1963 Corvette: Chevrolet Advance Information: Engine Crankcase Backfire

Subject: Engine Crankcase Backfire

Model and Year: All 1963 Corvettes Except Fuel Injection

Bulletin Number: #AI-63-10

1963 CORVETTE AIR CLEANER BASE

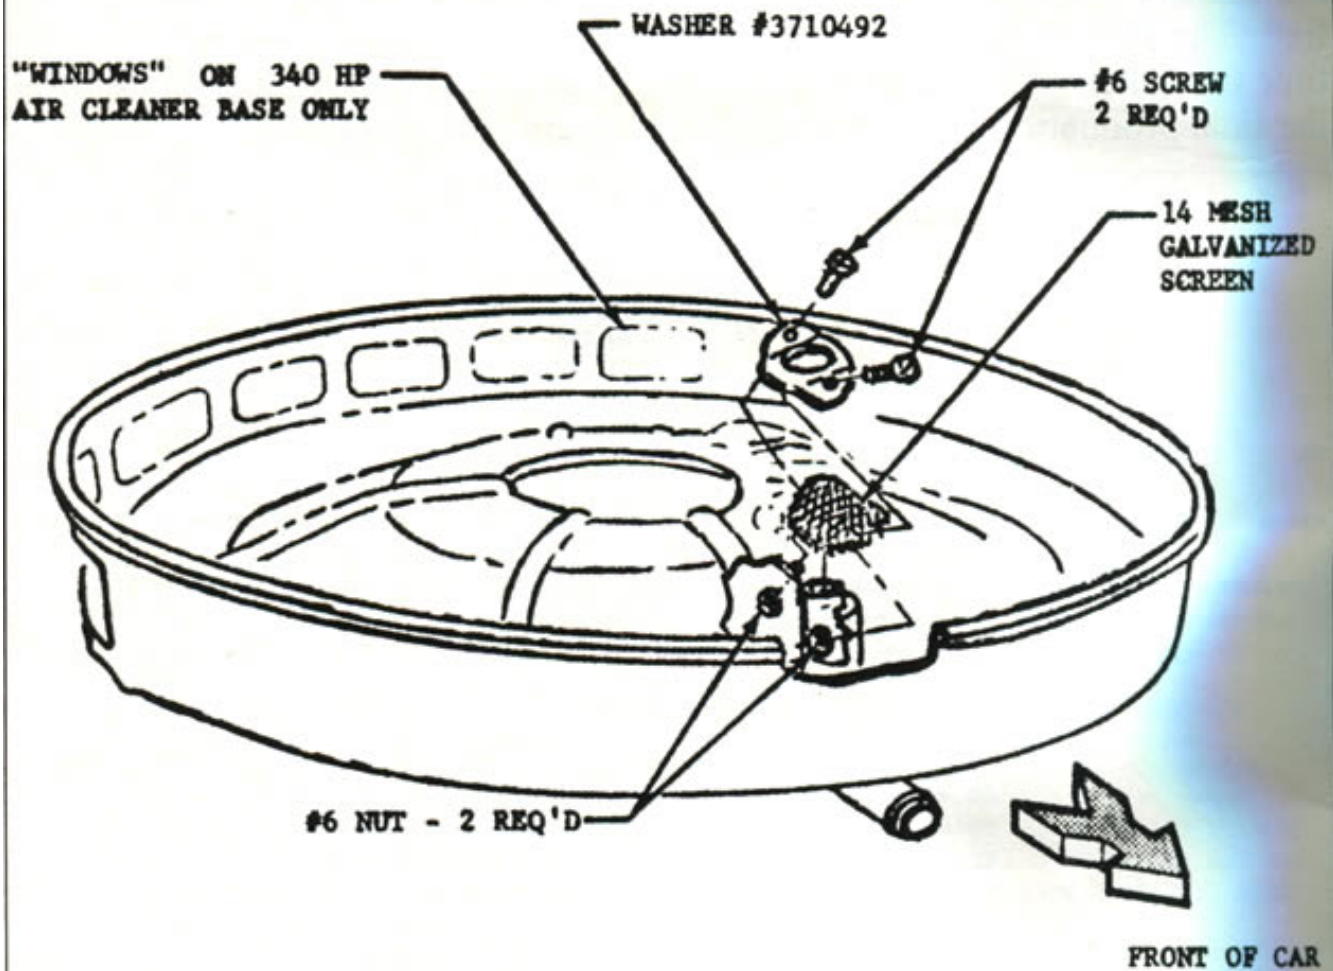
An accidental carburetor backfire during severe cold-weather starts, may result in a flame traveling down the air cleaner to crankcase vent fresh air supply tube, igniting the fumes in the crankcase. In extreme cases, the resulting explosion may damage the oil pan and rocker covers.

A final production correction has not been determined at this time; however, installation of a flame arrestor screen to the inside of the air cleaner (as illustrated on the attached sheet) will prevent re-occurrence of this condition.

FLAME ARRESTOR SCREEN INSTALLATION

Using 14 mesh galvanized screen, cut a circle approximately 1-1/2" in diameter and solder around outer edge of screen to prevent individual wires from being sucked into the engine.

Bend brake anchor pin washer Part No. 3710492, to fit contour of air cleaner. Position washer and drill two (2) 5/32" diameter holes through washer and air cleaner base. Place galvanized screen under washer and secure with two (2) #6 screws and nuts.

NOTE : Ends of screws must be cut short and "peened" over nut to keep engine vibration from loosening screws, allowing them to be swallowed through the carburetor.
